BEACON
Core Monitoring and
Operations Support System

BEACON
Core Monitoring and
Operations Support System
(WCAP-12473-A)
Addendum 1

**SUBJECT: ACCEPTANCE FOR REFERENCING OF LICENSING TOPICAL REPORT
WCAP-12472-P-A, ADDENDUM 1, "BEACON-CORE MONITORING AND
OPERATION SUPPORT SYSTEM"**

SAFETY EVALUATION BY THE OFFICE OF NUCLEAR REACTOR REGULATION

Figure 8-1

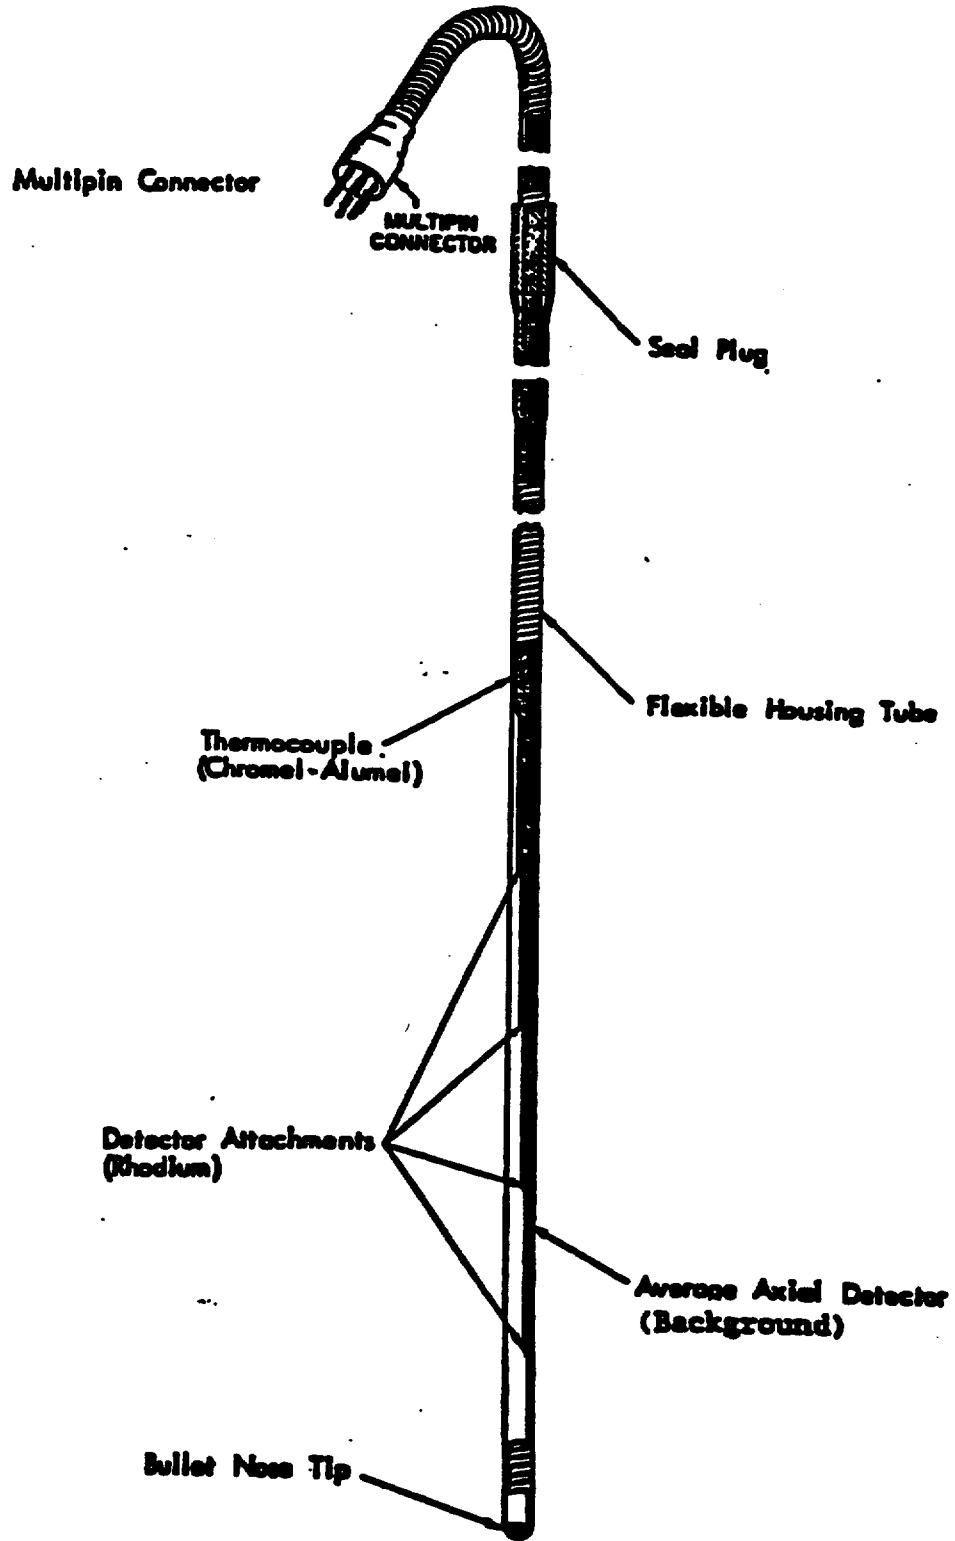
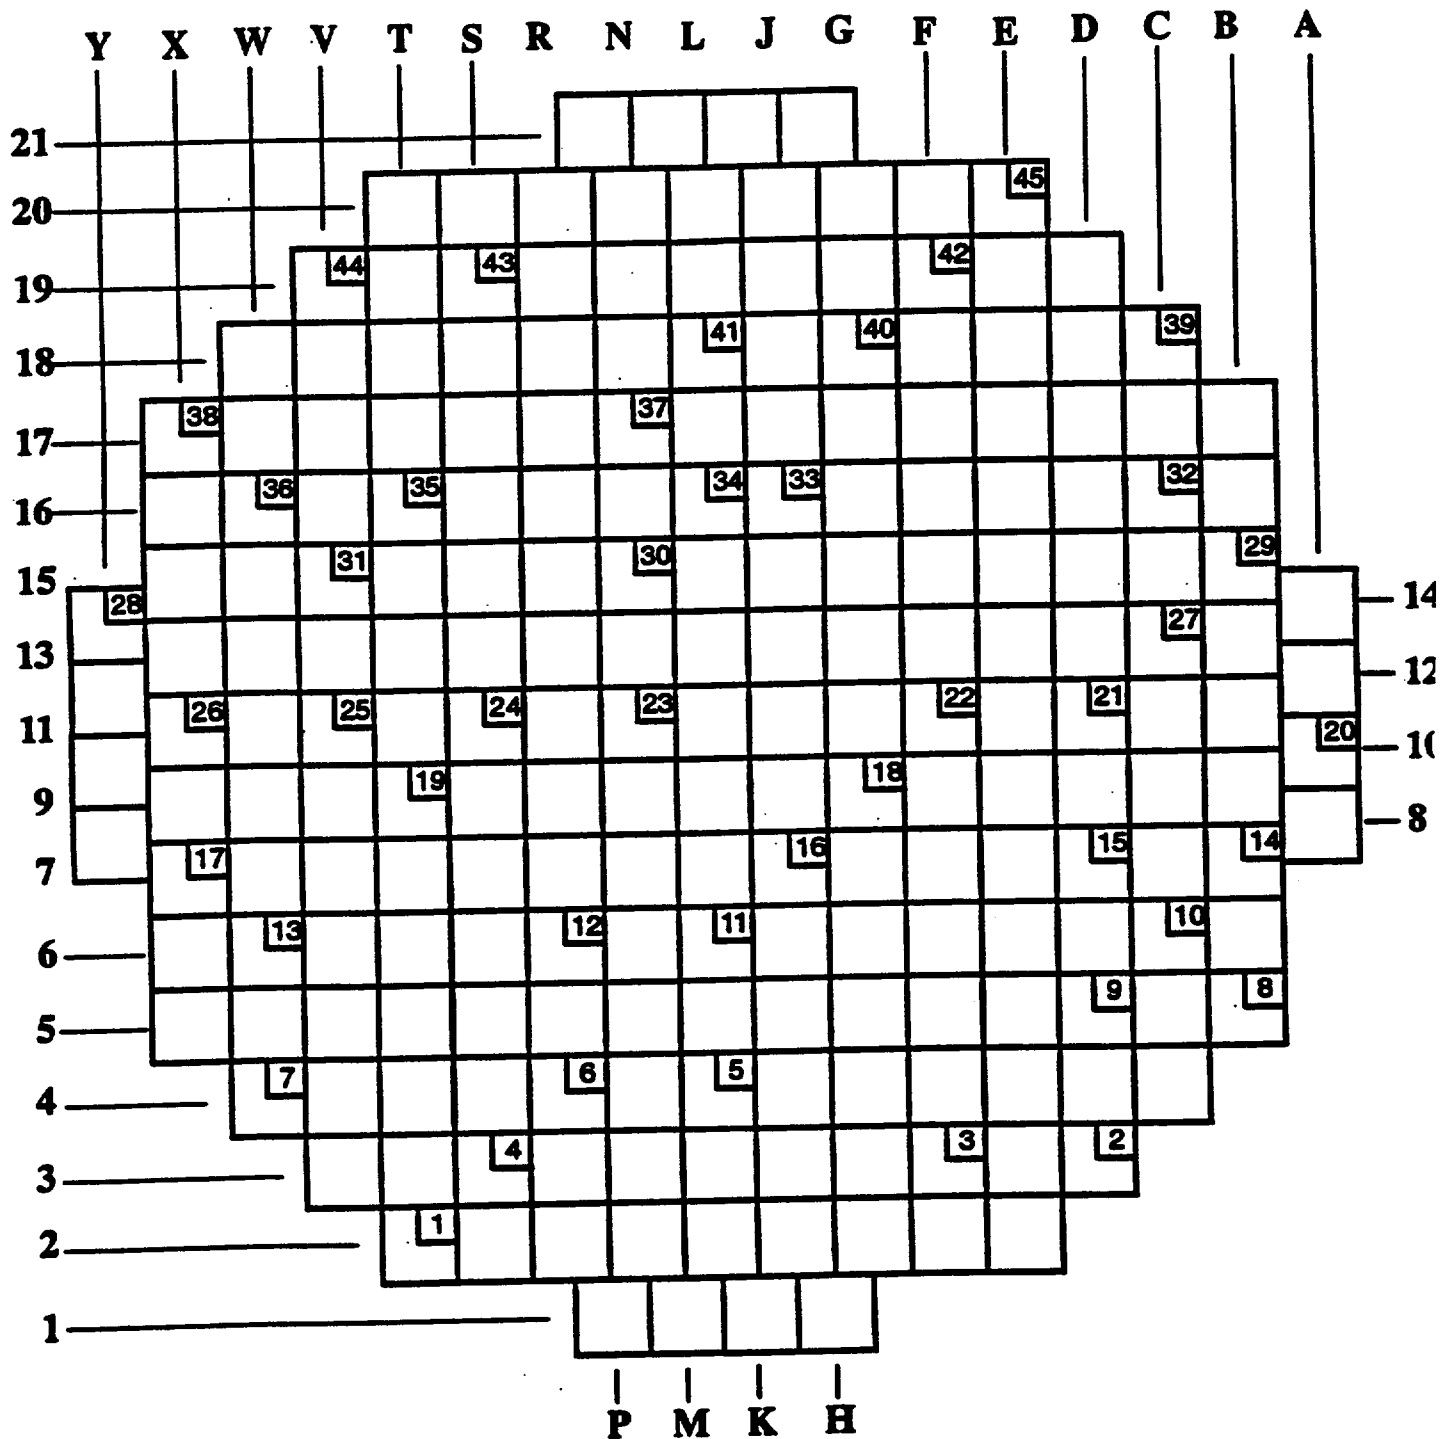
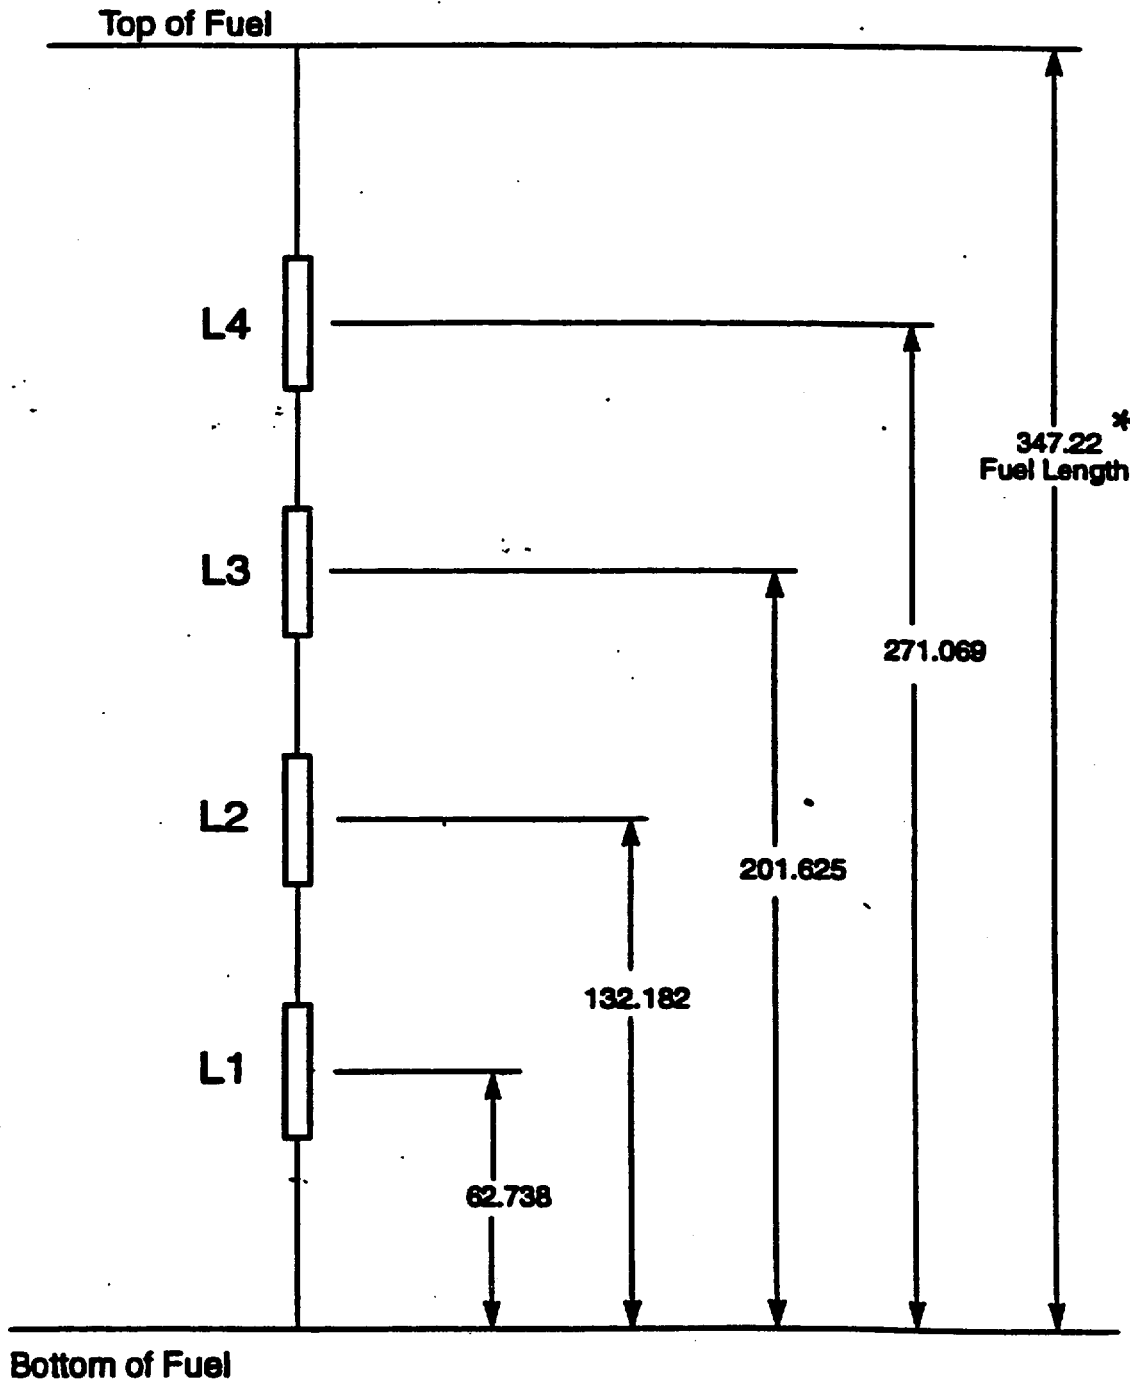
WCAP-12472-P-A contains information pertaining to the detector system description and qualification for the movable incore detector system. Please provide similar information for the fixed incore detector system.

As an example, the detector assembly and the detector layout of a typical 217 assembly CE plant is shown in Figure 8.1 through Figure 8.3.
